**Investigation into Alleged Environmental Violations by Central
Coalfields Ltd in Rohini OCP:**

**Report of Committee appointed by Hon'ble National Green
Tribunal in**

***Sanjay Chauhan vs CCL & Ors (OA No. 27/2020/EZ) vide order
dt.11.05.2020***

Date of submission: 14 September 2020

Figure 1. Location of Rohini OCP on the bank of the Damodar River, and of Dakra Siding used to despatch coal from this mine

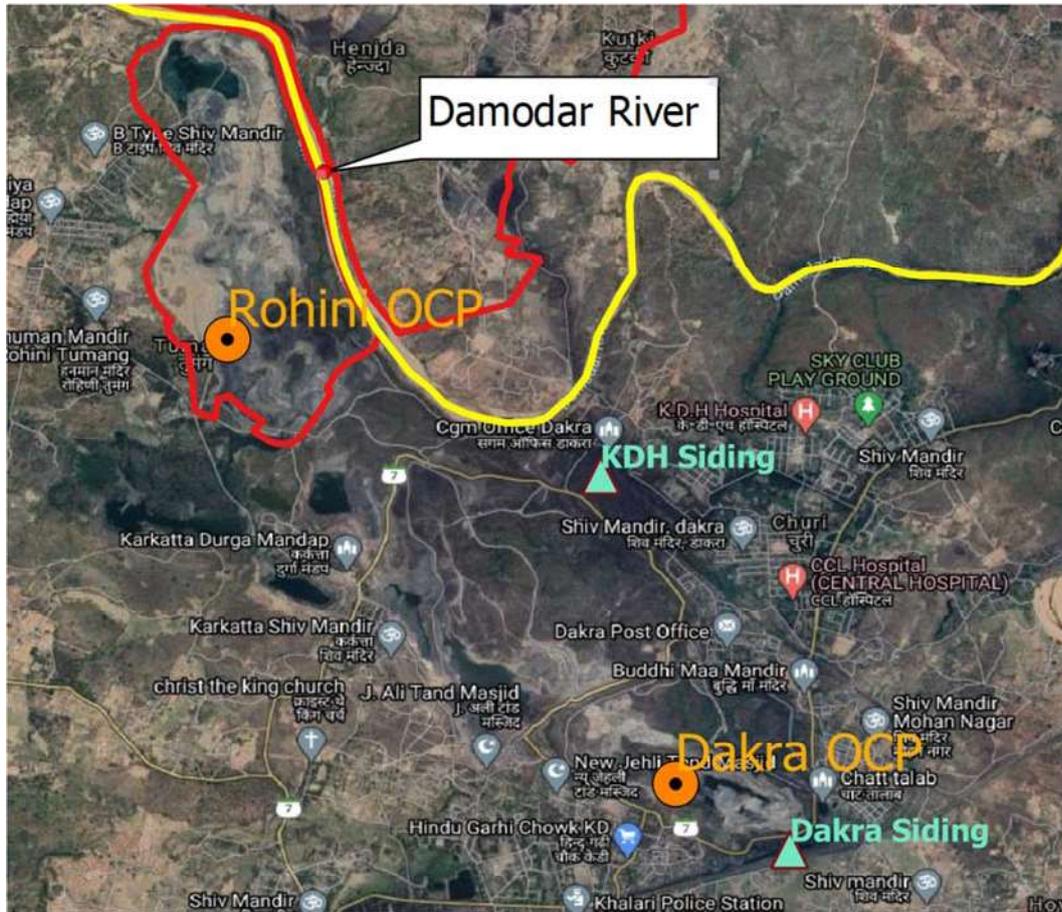
1. Since there is no EC condition requiring a CHP-cum-dedicated siding within the mining area, **as such there no non-compliance in this regard.**
2. However, while the expansion EIA/EMP (for which EC dt. 21.02.2017 was issued) mentions that coal transport by road **will take place to the KDH siding**, in the field it was observed that the coal from Rohini OCP was being taken by road to the Dakra siding, which is an addition 2.5 km distance (see Figure 1).
